Sunnyside Cogeneration Associates

RE: C/007/042 SCA-Star Point Refuse and Slurry
Task #4685 Response to NOV#12148

APPLICATION FOR COAL PERMIT PROCESSING

Title: Culvert Removal

SHEET
 731.720a

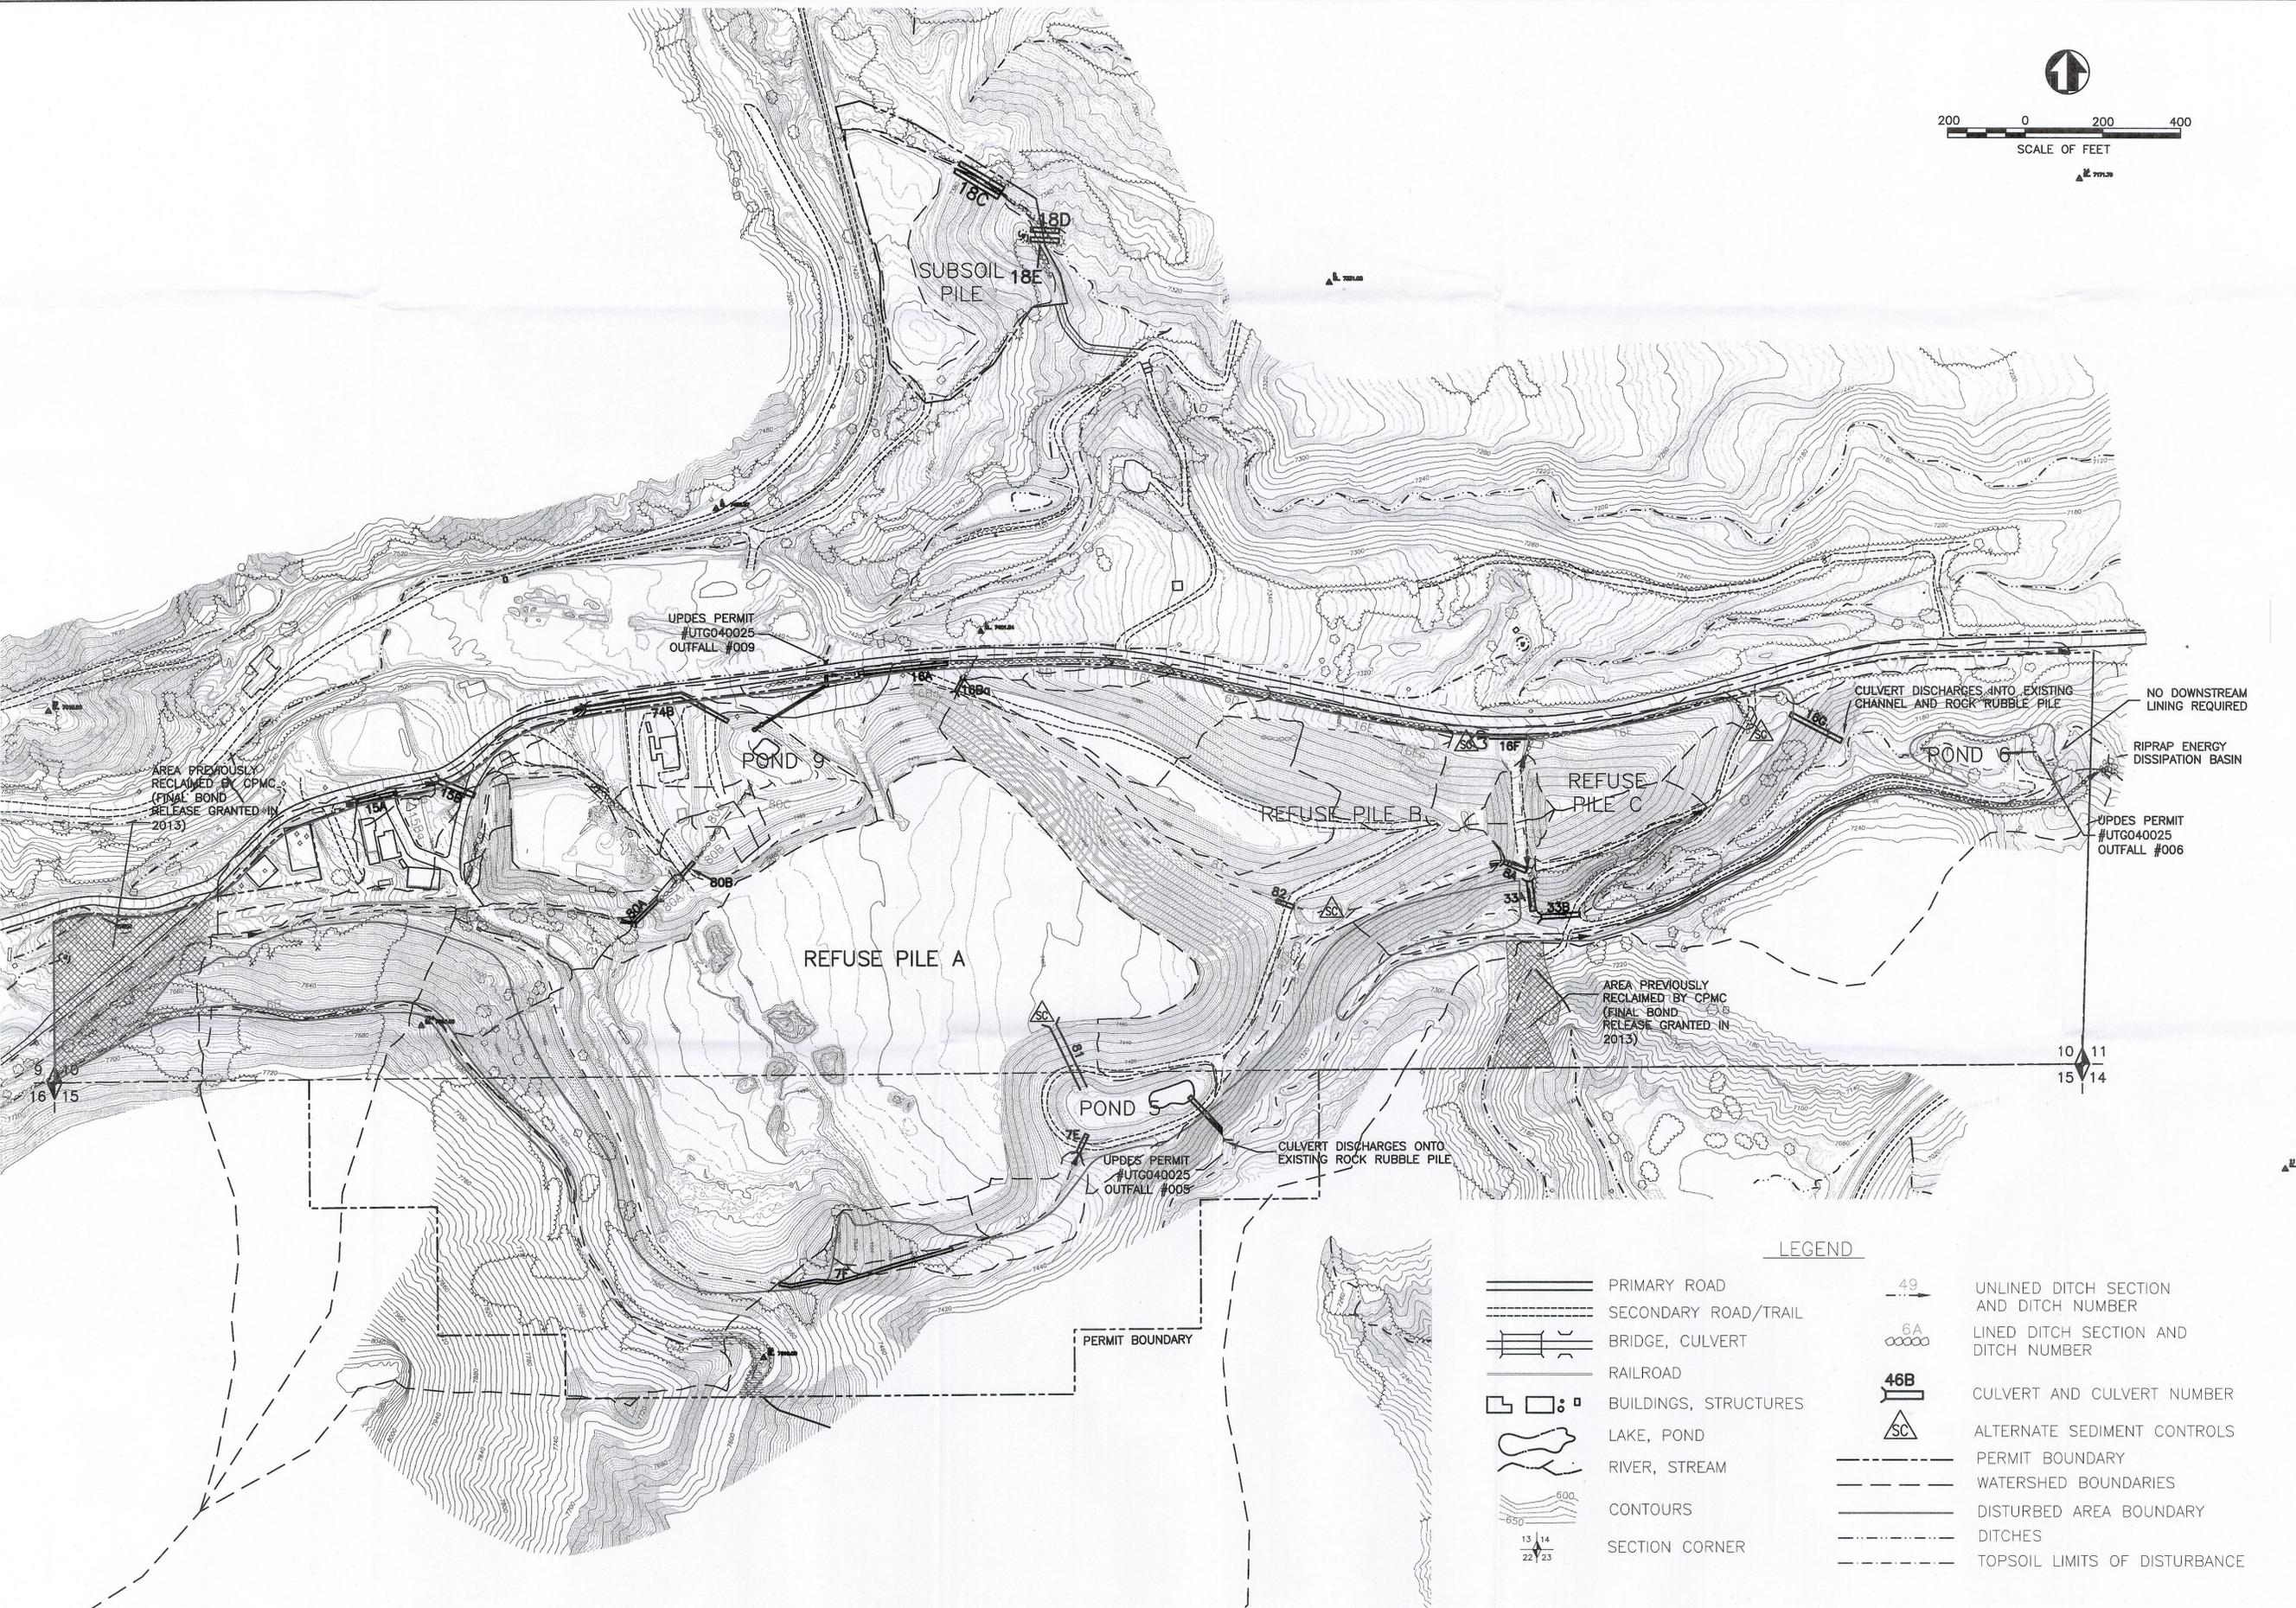
- Updated Maps 731.720a and 731.720b in relation to lined ditches 72A-C

- o The riprapped ditch observed during the site visit and represented on the photo provided with the review comments is the ditch 72B. That ditch was repaired this summer to address erosion concerns and SCA placed new rip rap in the ditch. We have updated the drawing 731.720a to more accurately label ditch 72B.

- o These maps have been updated to more accurately reflect the actual conditions in the field and specified on the design tables
- Riprapped ditch just north of the 72B ditch section
